ADDENDUM No. 3

INVITATION TO TENDERERS No.: 1220-020-2023-003

TITLE: GUILDFORD RECREATION CENTRE ROOF
REPLACEMENT

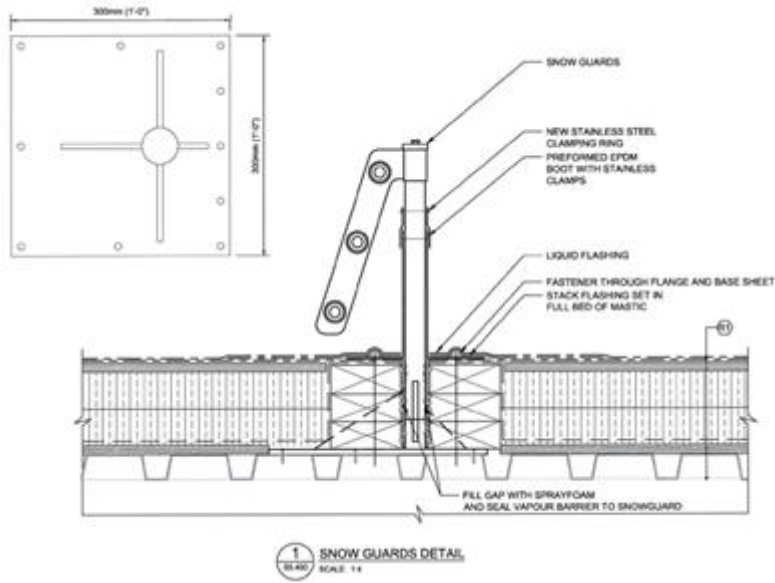
Q1. Please provide a supplier for these snow guards.

- .7 Snow Guards: SP2-M Snow fence for Membrane Roof. Any new Snow Guards must be accompanied by Shop Drawings stamped by a structural engineer registered in the Province of British Columbia.

- A1. Contractors are encouraged to source a supplier for the Snow Guards.**
- Q2. Would the City be willing to waive the wrap up liability coverage and accept proof of your commercial general liability insurance with a \$10,000,000 limit. Wrap-Up Liability for roofing jobs is difficult to obtain and costly if available.**
- A2. The City will waive its requirement for Wrap-Up insurance if there are no subcontractors required for the project. Contractors are still required to provide Commercial General Liability Insurance for a limit not less than \$10,000,000.00.**
